**ZONING AMENDMENT  
& SUBDIVISION STAFF REPORT****Date: November 5, 2009****APPLICANT NAME**

Anton Street Subdivision

**LOCATION**2421 Anton Street  
(West side of Anton Street, 3/10± mile North of West I-65  
Service Road North).**CITY COUNCIL  
DISTRICT**

Subdivision approval to create 1 lot, and Zoning approval to rezone the site from R-1, Single-Family Residential District, to I-1, Light Industry District, to allow a trucking company.

# SITE PLAN

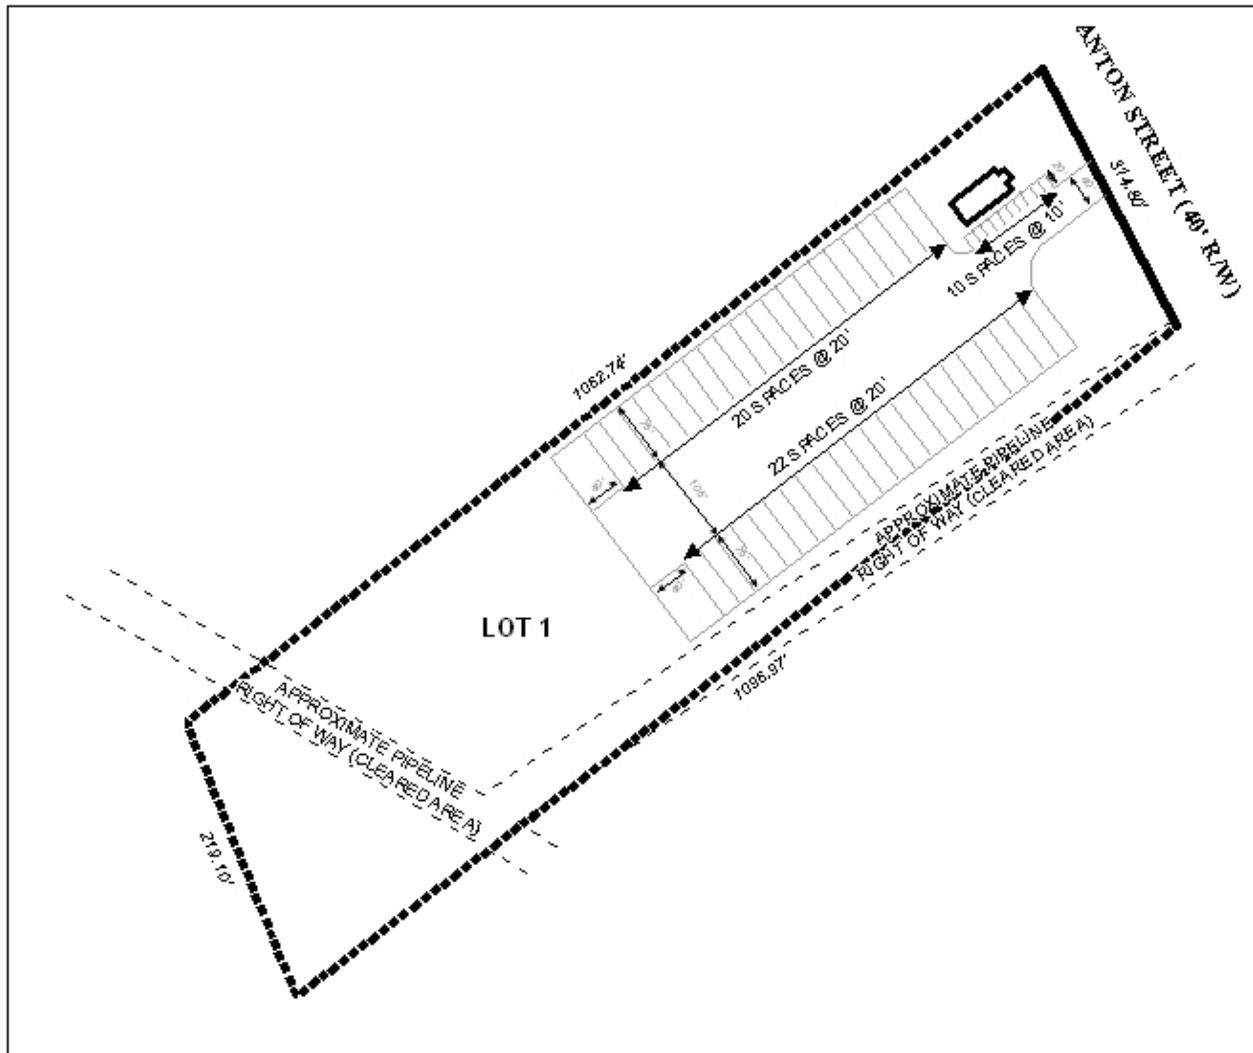
The preliminary plat depicts the proposed one lot, 7.8± acre subdivision. The lot depicted, however, does not encompass the entire tax parcel as shown on the tax assessor’s parcel data. The applicant states in the application that “Mobile GIS indicates there is additional property that should be included with this parcel.” The applicant further states that the property was foreclosed on, and that the applicant only purchased a portion of the property. Further, the applicants are requesting that the remaining portions of the parcel not be included. According to the records of the Probate Court, the applicant’s purchased this property in 2008. If indeed the applicants only purchased a portion of the parcel in 2008, then an illegal subdivision of land occurred, and this must be corrected by the preliminary plat being revised to include all portions of the parent parcel.

Otherwise, the proposed lot appears to meet the minimum size requirements as regulated by Section V.D.2 of the Subdivision Regulations. However, the proposed lot size is not indicated on the plat. The lot size, in square feet, should be depicted on the plat, or a table with same information provided.

The site fronts onto Anton Street, a minor street, not provided with curb and gutter. Section V.B.14 of the Subdivision Regulations requires a right-of-way of 60 feet for minor streets not provided with curb and gutter. Accordingly, dedication sufficient to provide 30 feet from the centerline of Anton Street should be required.

The 25-foot minimum building setback is not depicted for proposed lot, but would be required on the final plat, if approved. The 25-foot setback line should be depicted behind any required dedication.

*preliminary plat with the exception of the property line dimension along Anton Street. This dimension should be corrected to read 214.50 feet, as noted on the legal description.*

- 1) Address the discrepancy between the proposed lot and the remaining portions of the parcel by inclusion in this application;
- 2) Depict the dedication sufficient to provide 30 feet from the centerline of Anton Street;

- 3) Depict the 25-foot setback line behind any required dedication;
- 4) Depict the lot size, in square feet, on the plat; and
- 5) Depict compliance with Engineering Comments: *“Must comply with all storm water and flood control ordinances. Add a note to the plat that detention must be provided and a land disturbance permit will be required for any cumulative increase in impervious area added to the site in excess of 4000 square feet. Wetlands are shown on the City of Mobile GIS database. Need to show the limits of the wetlands on the plat or supply documentation that the wetlands do not exist. Add a note to the plat that any development within the limits of the wetlands is prohibited without the approvals of the City Engineer and the Corps of Engineers. Any work performed in the right of way will require a right of way permit.”*

- 1) Revision of the plat to correct the property dimension along Anton Street;*
- 2) Retention of all plat notes on the preliminary plat;*
- 3) Provision of a note on the final plat limiting the site to two curb cuts to Anton Street, with the size, design, and exact location of all curb cuts to be approved by Traffic Engineering and conform to AASHTO standards;*
